DESIGN/DEVELOPMENT REVIEW COMMISSION

EVALUATION SHEET

ADDRESS: 1301 Richland Street, Ebenezer Lutheran Church

NATURE OF REQUEST: Request Certificate of Design Approval for new fence

Plat Showing Fence Installation - Ebenezer

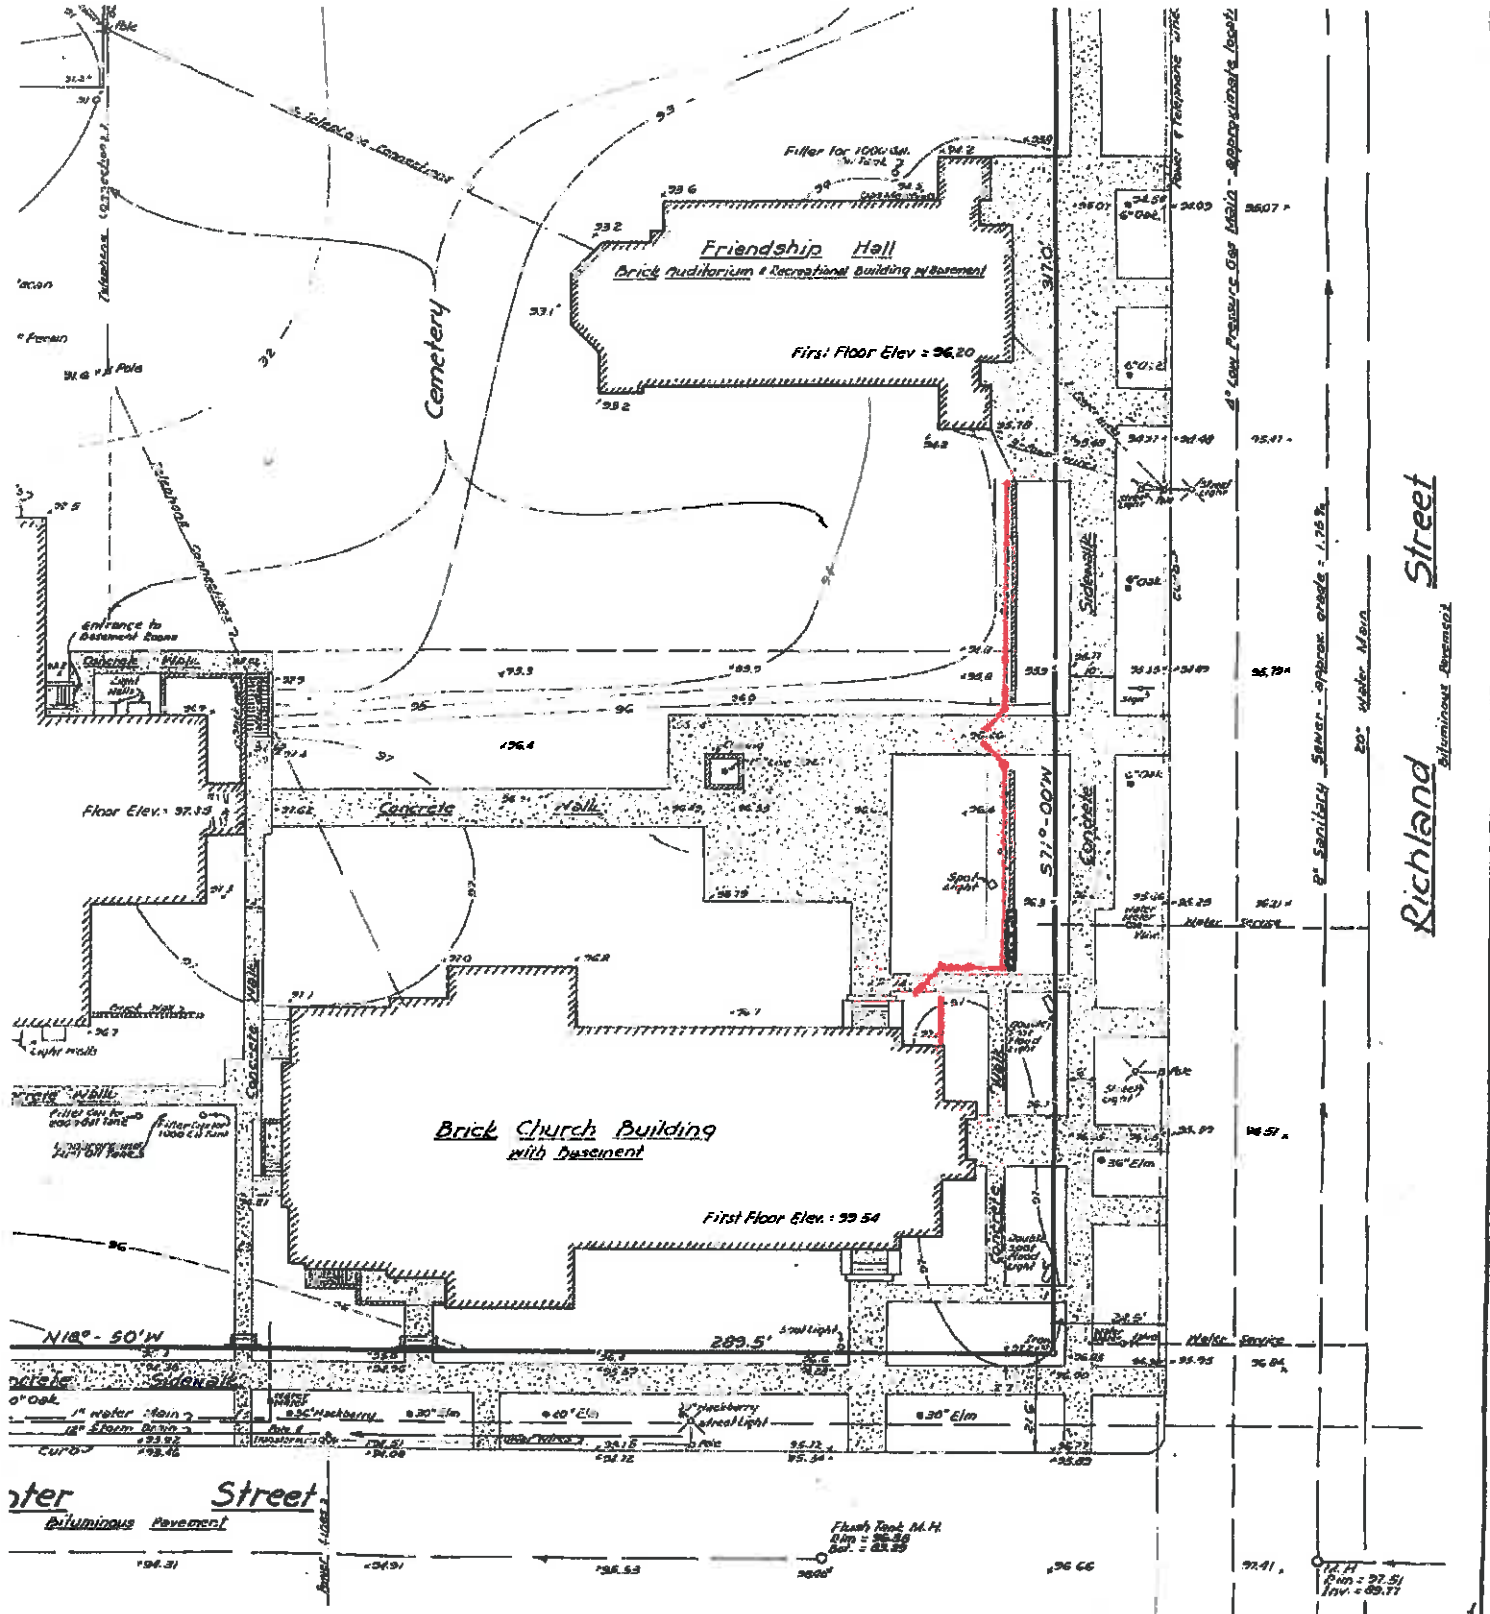
The proposed fence would start at the nave of the church at the front right corner (as one faces the church), extend with a gate across the sidewalk, and then move in a perpendicular fashion to extend south to the Richland Street-facing extant brick wall. It would then run parallel directly behind the brick wall, inches away from it, and extend across the second sidewalk, moving along behind the second extant brick wall for at least a few feet. Please see the attached photos for more information regarding the existing walls and fences on the property.

Because the proposed layering of fences directly behind one another is not consistent with historic landmark or district patterns, staff cannot recommend for this proposal. Likewise, the City's Zoning Ordinance allows for a maximum height of 4' in front yard setbacks, which this fence would fall partially into, so the proposed fence height of 5' is an issue. Church members feel that anything less than a 5' fence would not deter vagrants. Please note that the applicants submitted photographs of other fences that are 5' or higher—staff found that they were either historic/long existing fences or were at side or rear yards which allow for greater heights.

The first proposal is that the fence would start at the nave and move in a straight line across the property. This pushes the fence back behind the front wall of the church and would allow for up to a 6' height because the zoning code allows for such a height in side yards. Since the church needs to expand into the green space on certain occasions, large gates or a series of gates could be installed in the fence along the green space to open on those days to allow easy flow between areas. Terminating the fence on the right side of the property would require working out some details as there is an approximately 48" fence running lengthwise here.

Another suggestion is to allow the fence proposal with the modification of a dense 5' tall landscape buffer immediately behind the wall and then the suggested 5' fence installed behind it. This would negate the design issues if the fence couldn't be seen. Staff would suggest hollies or other evergreen shrubbery which is prickly enough to serve as a further deterrent. Staff believes this could be worked out with Zoning. However, the landscaping would have to be installed prior to the fence installation, as previous approvals, which depended upon landscaping, have not always been executed as approved. It would be necessary for the church to agree to keep the landscaping at a minimum of 5' height. Additionally, the height of the fence on the sections which run parallel to the church might have to be modified or screened to meet requirements.

Staff cannot recommend for the proposal as it stands, according to Section 17-674 of the City ordinance, but could recommend for one of the options listed above in the evaluation, with details being worked out with staff. Landscape buffers will need to be fairly close in height to the 5' at the time of fence installation if this solution is approved. Staff also will need to see the specifications of a proposed fence prior to its being installed.

Plat Showing Fence Installation - Ebenezer

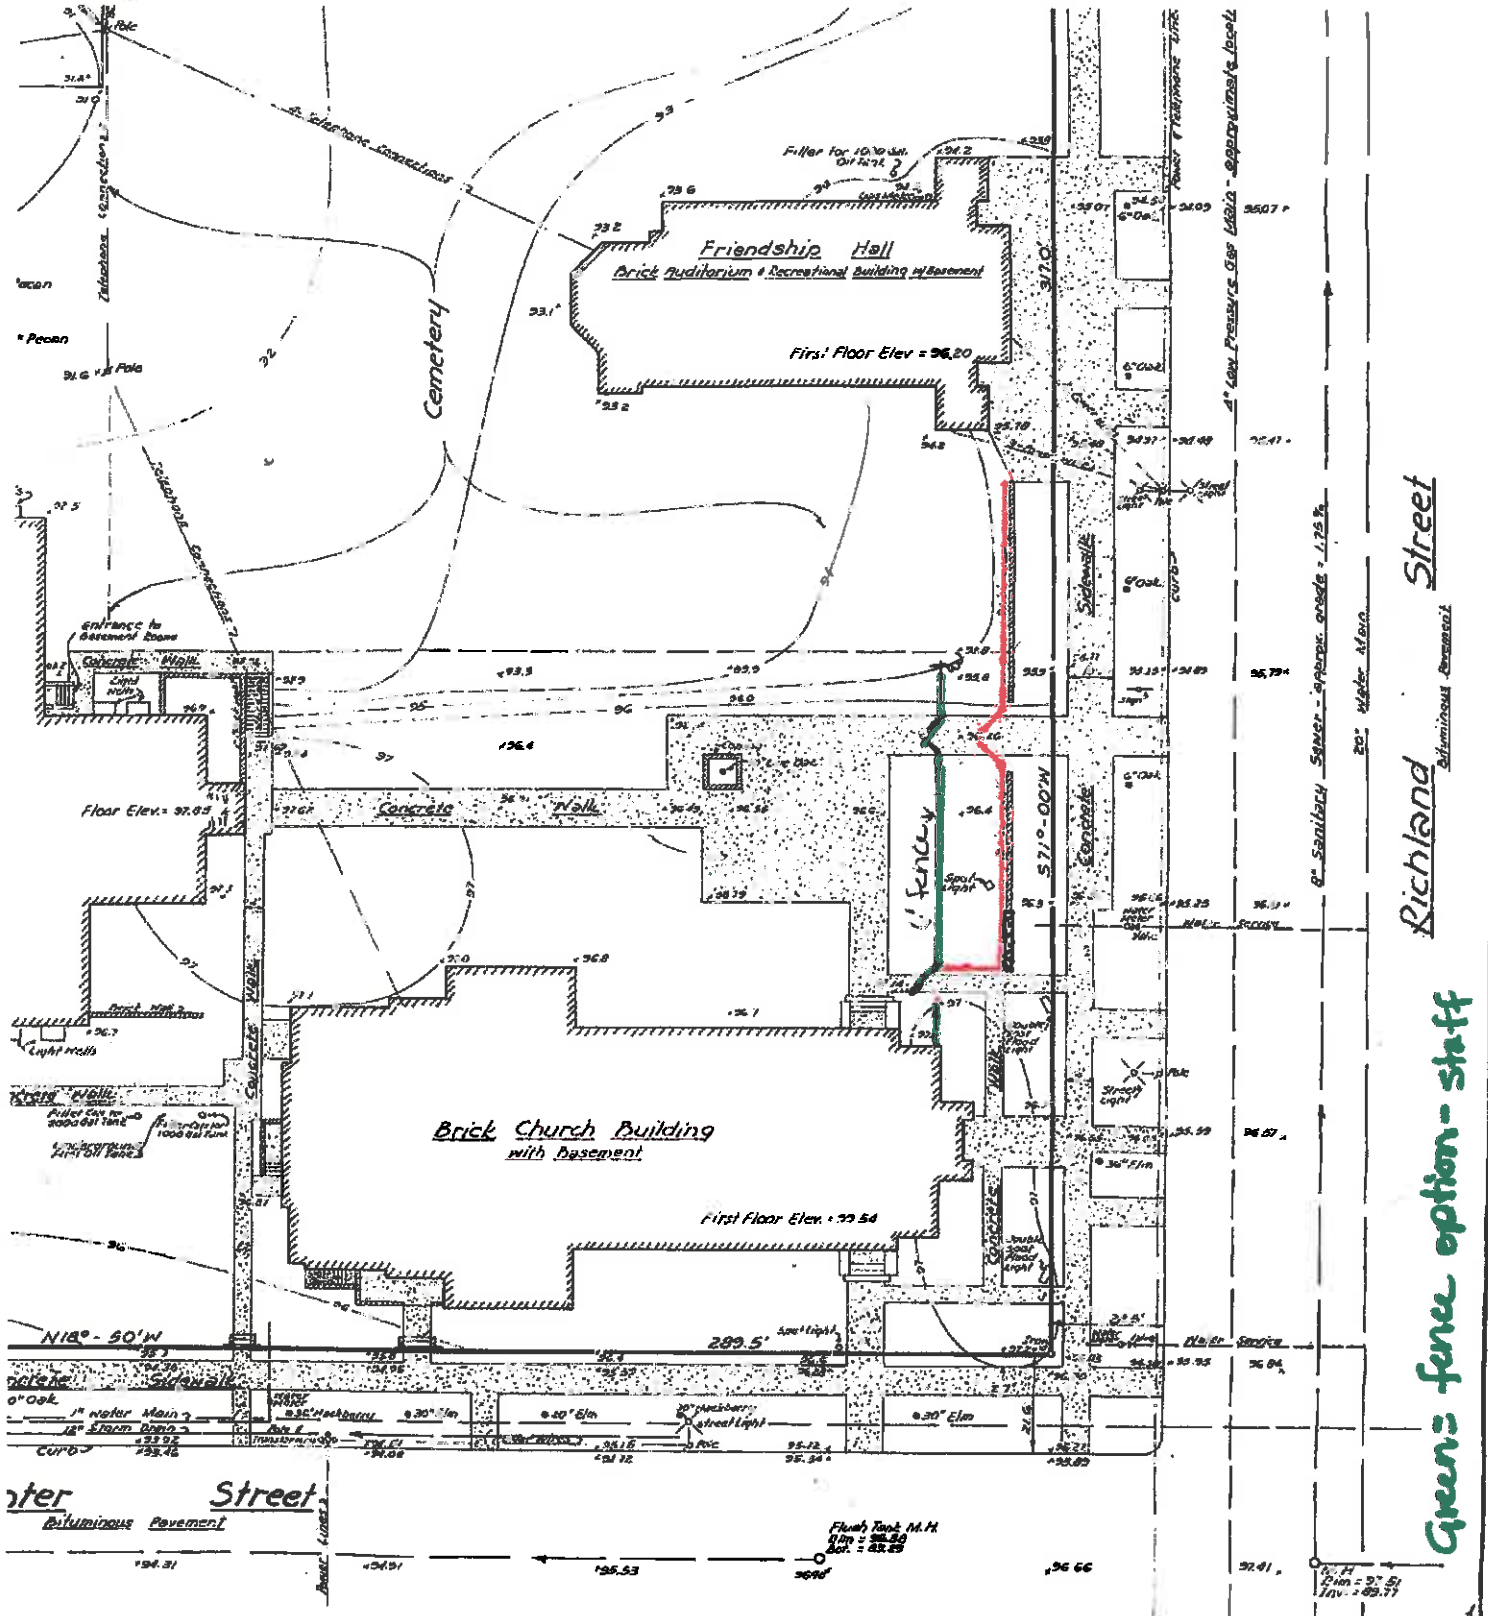
Green: fence option - staff
